# **APPROVED**

NMOCD approves of the proposed delineation for 1RP-4646, 1RP-4655, and 1RP-4718 with clarifications:
1) Annotate the 3 releases on a scaled map.
2) Laboratory analyses must demonstrate permissible BTEX, TPH extended, and chlorides for at least 2 depths for each

## 1RP-4646, 1RP-4655 & 1RP-4718 DELINEATION PLAN Lea Unit West Battery Lea County, New Mexico

LAI Project No. 17-0175-35

Figure 2 - Aerial Map Showing Proposed Sample Points

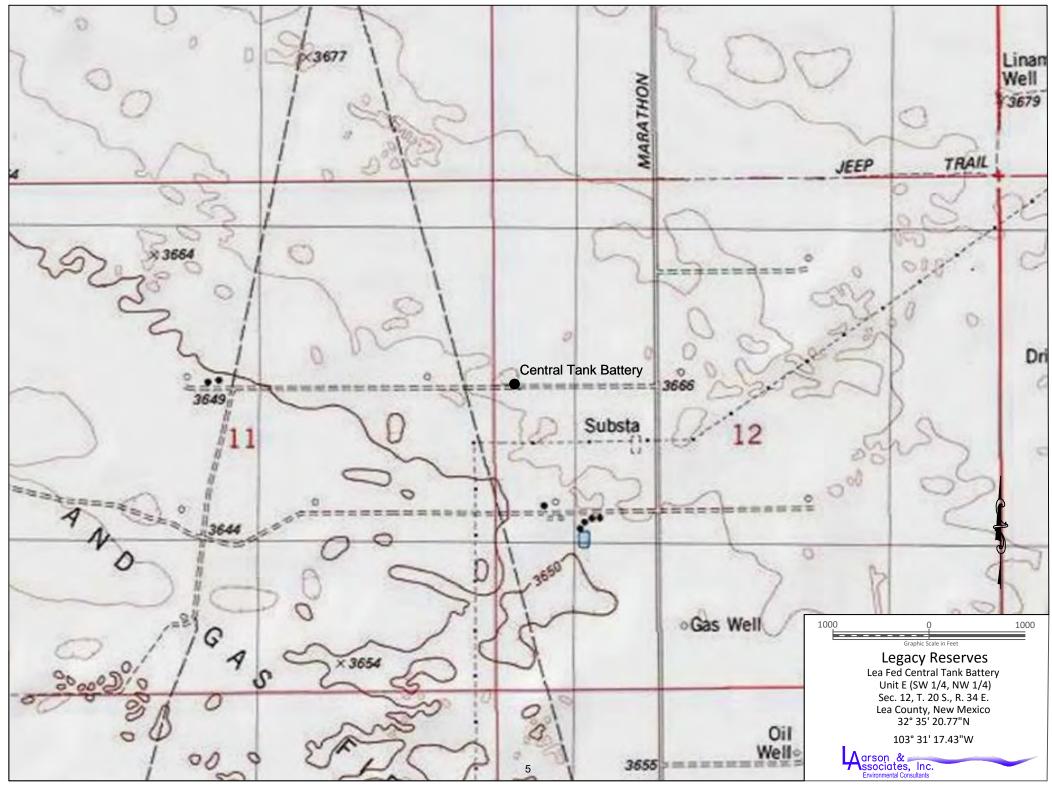
## sample location.
